Addendum 3 for RFB927940-04

Project Name: WRC Decentralization Phase 4 & Fire Alarm Phase 3 (9279.40 & 9279.41) Bid Issuance #4
DAS RFB #: 927940-04
DAS Project #: 9279.40 & 9279.41
Date: 6/2/2026

A6 BUILDING D AHU MECHANICAL PLAN
1/4" = 1'-0" 0' 6"

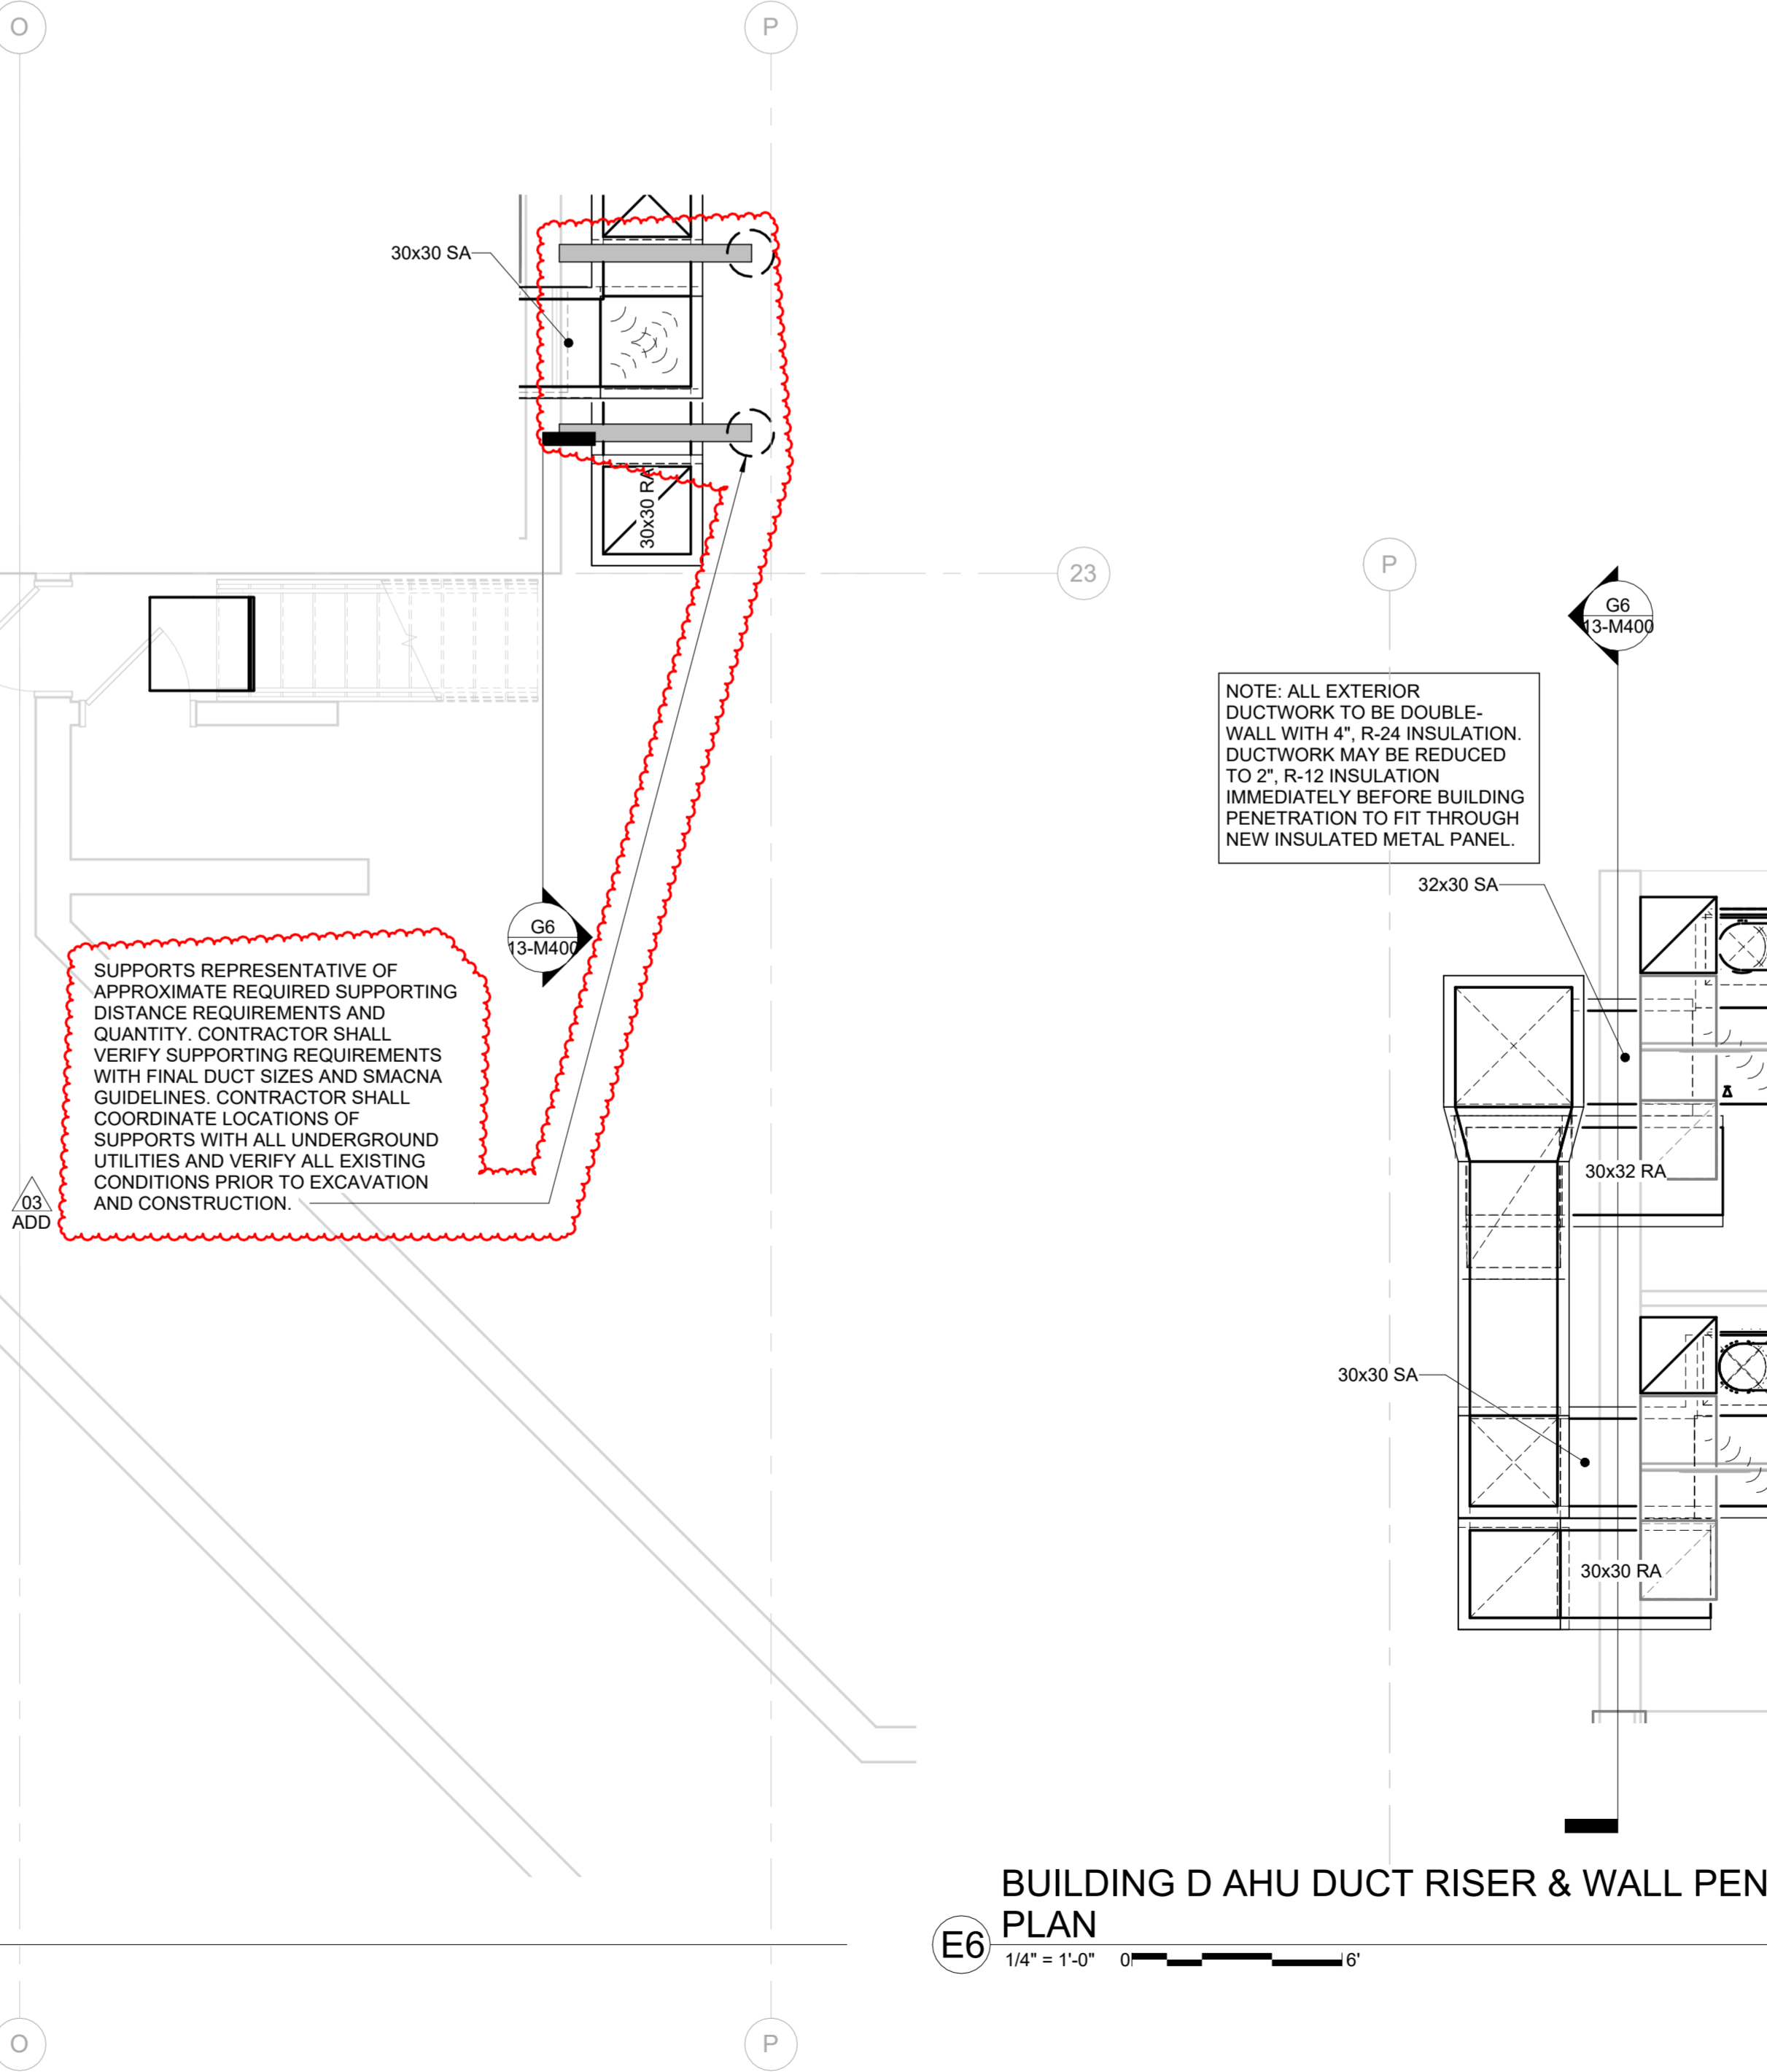
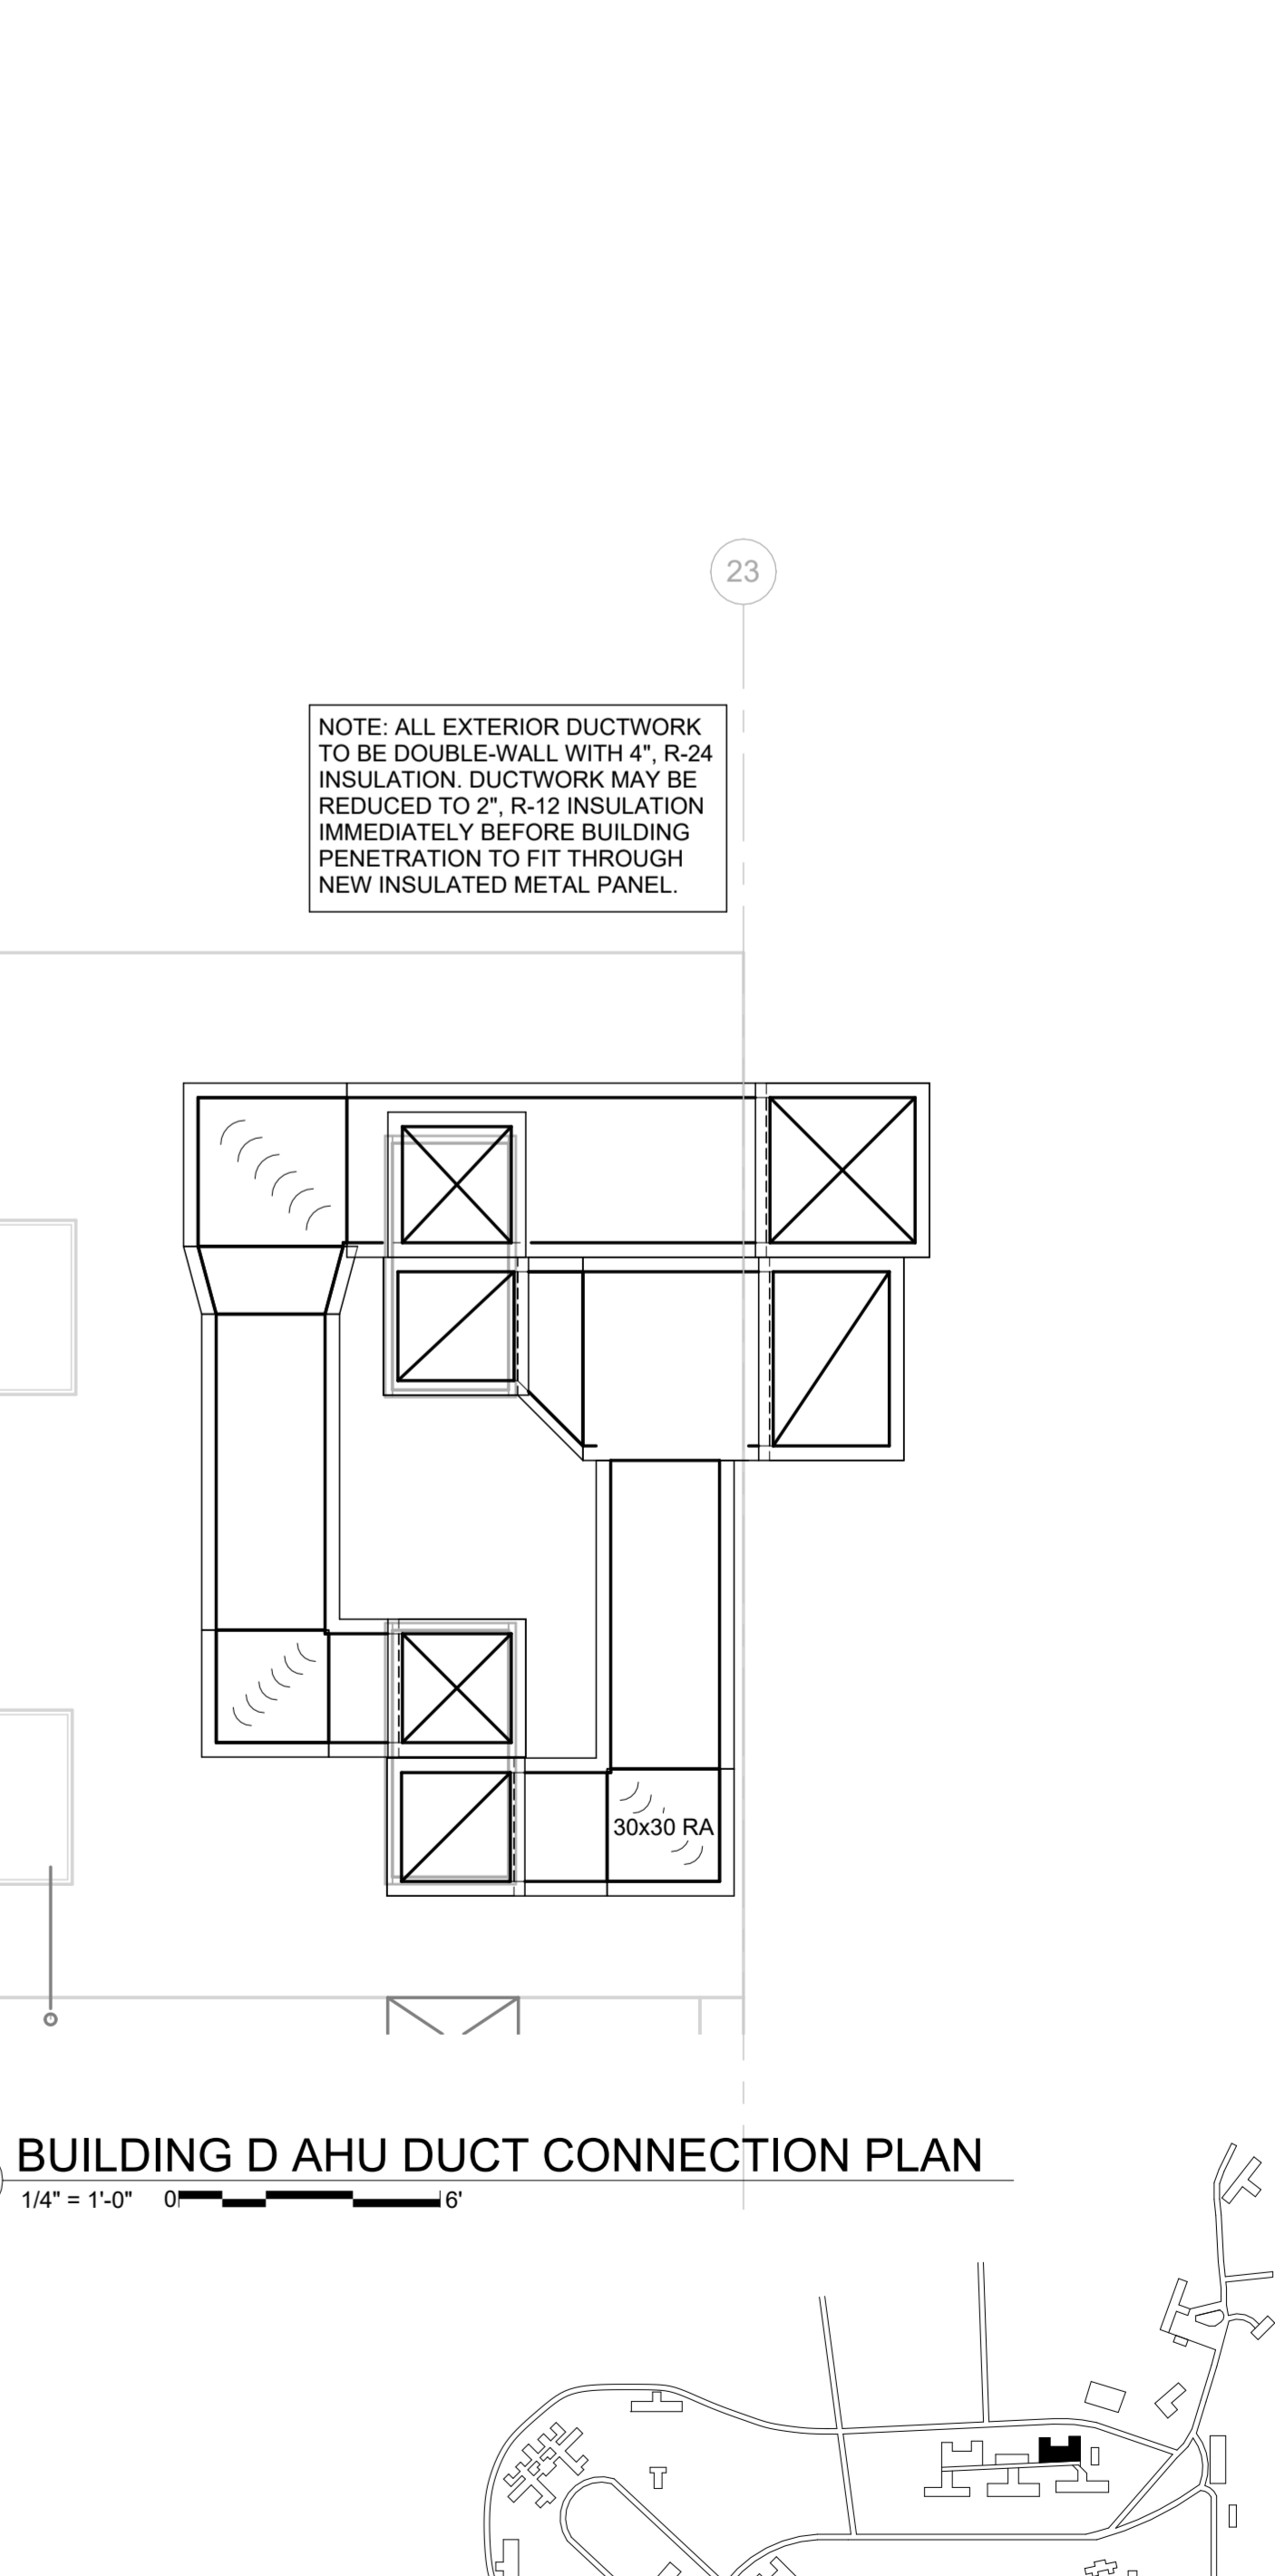
- **13-M300 – THERMOSTAT PLAN:**
 - **ADD** Tags to EUH-D-2 and ACCU-D-2.
- **13-M400 – BUILDING C & D ENLARGED AHU PLANS:**
 - **ADD** Approximate duct support locations to exterior ductwork and associated note “SUPPORTS REPRESENTATIVE OF APPROXIMATE REQUIRED SUPPORTING DISTANCE REQUIREMENTS AND QUANTITY. CONTRACTOR SHALL VERIFY SUPPORTING REQUIREMENTS WITH FINAL DUCT SIZES AND SMACNA GUIDELINES. CONTRACTOR SHALL COORDINATE LOCATIONS OF SUPPORTS WITH ALL UNDERGROUND UTILITIES AND VERIFY ALL EXISTING CONDITIONS PRIOR TO EXCAVATION AND CONSTRUCTION.”
